Enbridge Gas Inc.
 500 Consumers Rd.
 North York, ON M1K 5E3
 Canada

**Re: Enbridge Gas Inc. (“Enbridge Gas”)
 Ontario Energy Board (“OEB”) File: EB-2022-0157
 Panhandle Regional Expansion Project (“Project”)
 Hybrid Hearing Undertaking Responses and Transcript Corrections**

Figure 1

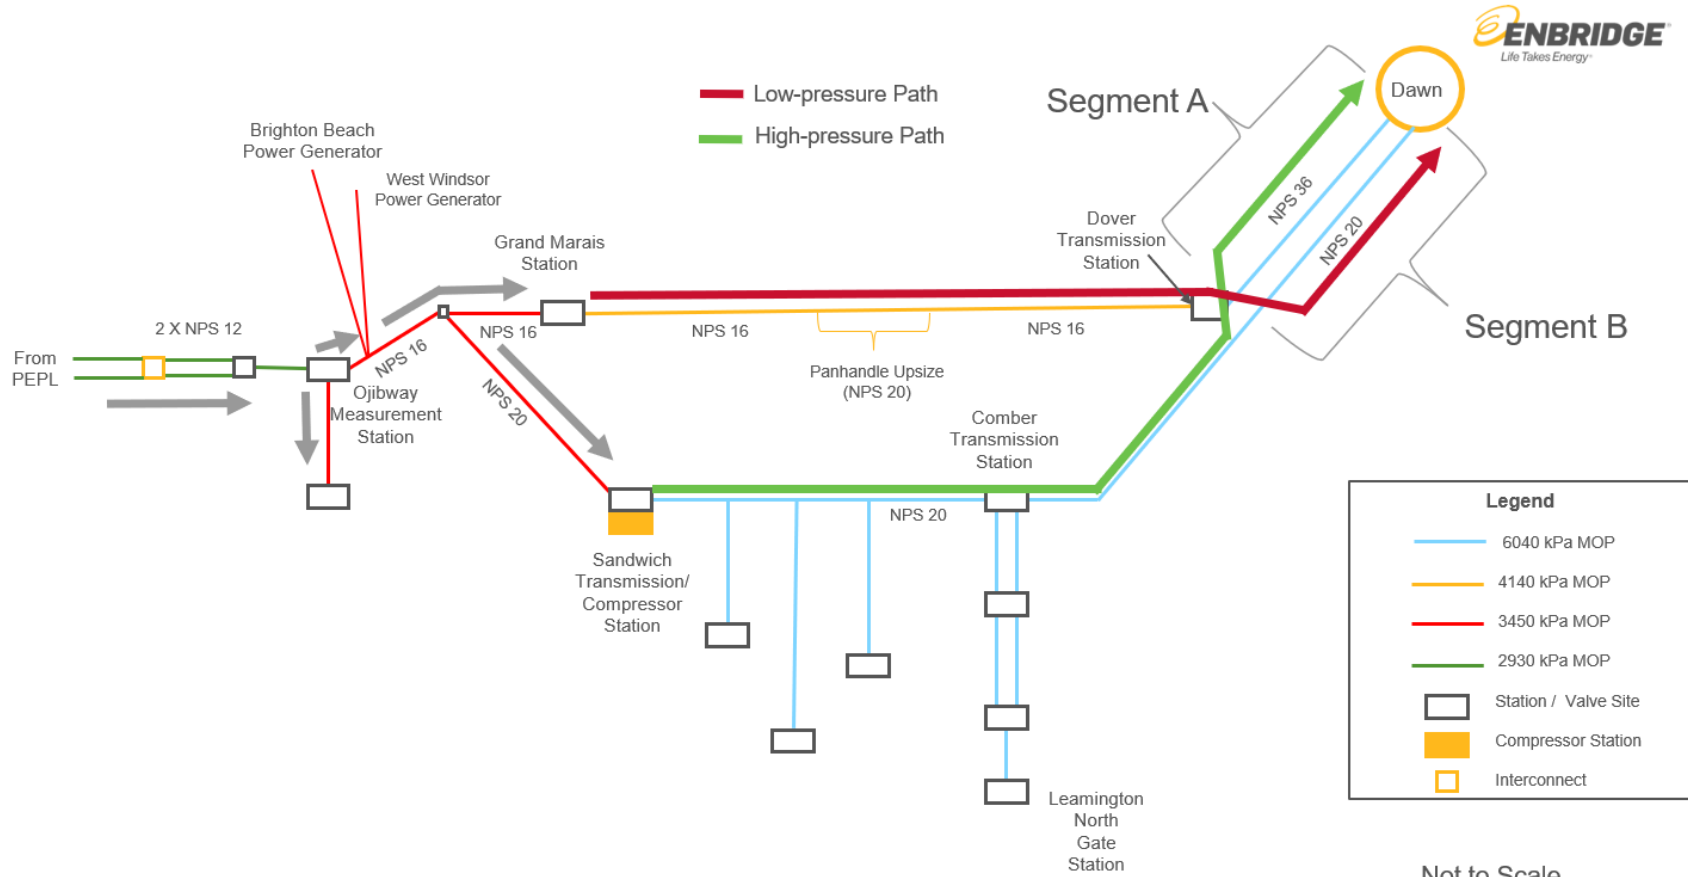
Enbridge (1) to provide figures to the summer operating pressures indicated by the green line; (2) to advise how low could that regulator be set to meet the summer needs of the green line market during summer operations.

When gas is flowing towards Dawn on the “Low-pressure Path” (please see Figure 1) the gas typically arrives at Dawn at a low pressure. When the pressure is too low, gas flows through Dawn into low-pressure markets if they are available. These low-pressure markets are not always guaranteed to be available during the summer and when they are not, the system cannot flow into Dawn. The path is also not guaranteed due to system set up to manage maintenance activities along the path or at Dawn.

When gas is flowing towards Dawn on the “High-pressure Path” (please see Figure 1), the Dawn control valves are set lower to facilitate the import of gas. The control valves at Dawn must be held at a higher pressure (around 4830 kPag) to maintain reliable service and manage intra-day demand fluctuations of the Panhandle Transmission System.

Hybrid 1: With NPS 36 Loop (17.86 km), +21 TJ/d Ojibway Supply (+168 TJ/d incremental capacity)

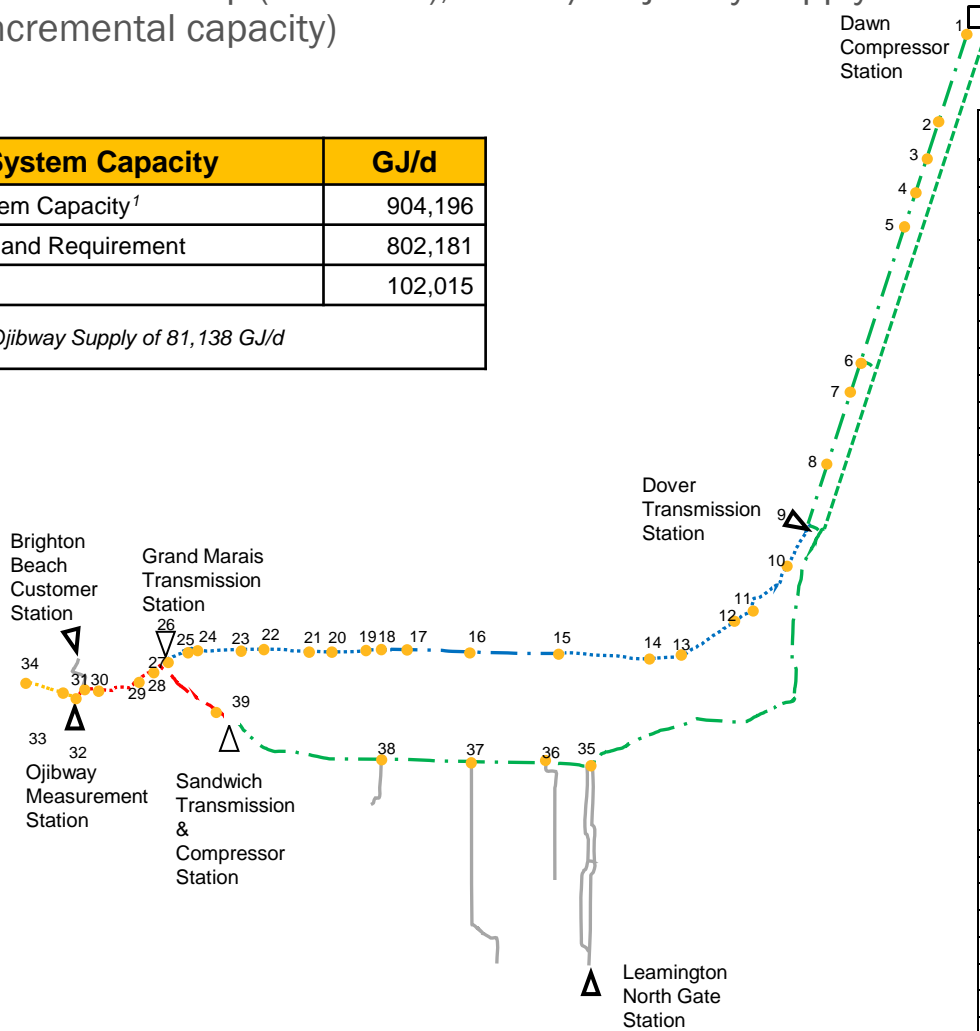
¹ FRPO's first additional undertaking request: "For the Hybrid Alternatives in Table 4, please provide the simulation results in the same format as the base case of Exhibit I.FRPO-18. These simulations should already be completed to develop the incremental capacity shown in the table."

Please see Attachment 1 for the schematic and table showing the requested pressures and flows related to Hybrid Alternative 1: 17.86 km NPS 36 with +21 TJ/d incremental Ojibway supply for Winter 2024/2025.

B. Cost Impact Breakdown of Risks

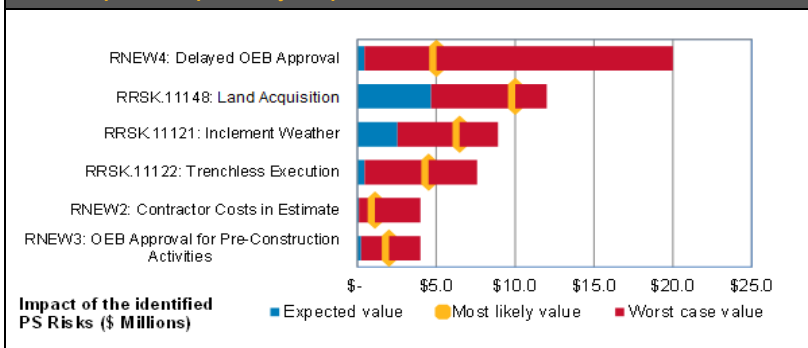
EGL to file a risk analysis showing specific risks, contingencies, and likely impacts on the project

The top risks identified as part of the Project's risk assessment were delayed land acquisition and delayed OEB approval of the Project. These risks could have a direct impact on the Project's schedule and could impact the estimated Project cost if schedule compression is required to maintain the target in-service date.

Enbridge Gas uses an established contingency estimating methodology based on AACE® International RP 10S-90 recommended practice. Enbridge Gas's practice for contingency estimating uses the combination of a parametric model (for treatment of systemic risks) and expected value plus critical path modeling (for treatment of project-specific risks). Please see Attachment 1 for the Project's contingency report summary which was used to establish the \$20.8 million contingency figure in Table 1 in response at Exhibit I.SEC.2. Enbridge Gas continues to monitor contingency throughout the lifecycle of the project.
